**Subject** ▶ Change on tool holder, impact bolt, etc.

**For Models** ▶ HM1500 (Demolition Hammer)

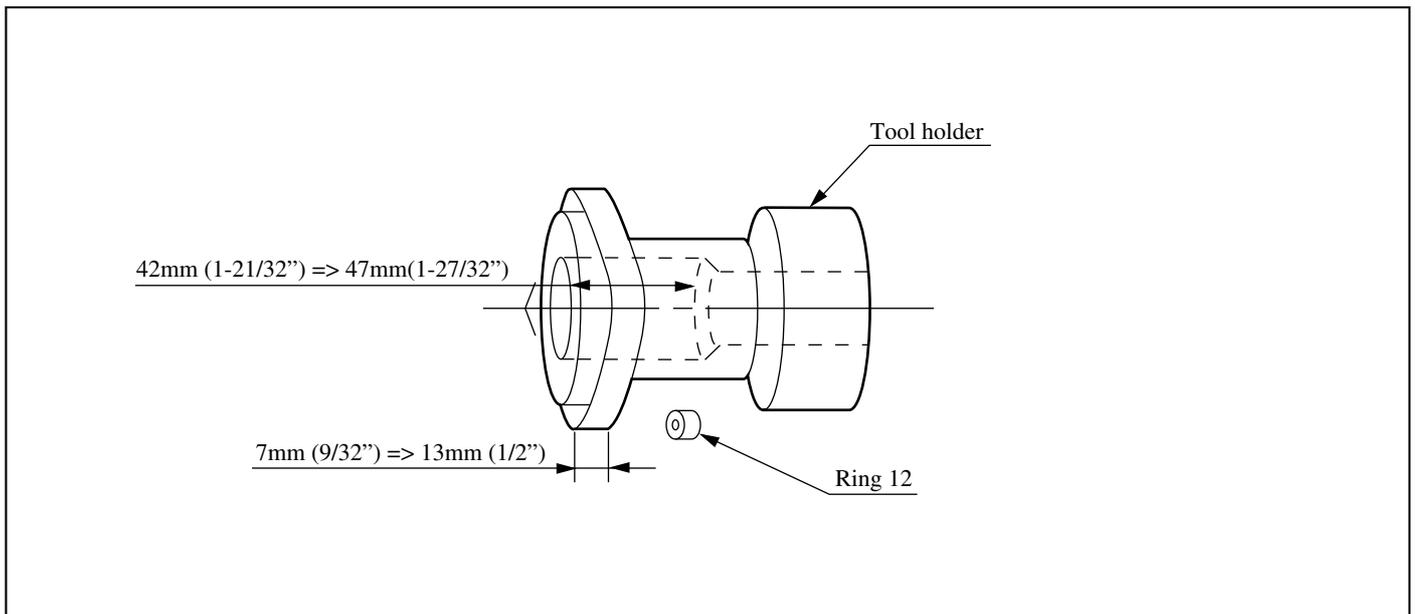
1. The impact bolt will be changed from 69mm (2-23/32") to 74mm (2-29/32") in length.

2. The hole in the tool holder will be changed from 42mm (1-21/32") to 47mm (1-27/32") in depth.
3. The tool holder will be hardened.
4. The flange of the tool holder will be changed from 7mm (9/32") to 13mm (1/2") in thickness.
5. The ring 12 will be discontinued.

Item No.	Current part		Q'ty	New part		Q'ty	I/C	Note
10	Impact bolt 322384-9		1	Impact bolt 322693-6		1	No	Interchangeable as a set
7	Tool holder 322514-2		1	Tool holder 322692-8		1	No	
102	Ring 12 257182-1		4
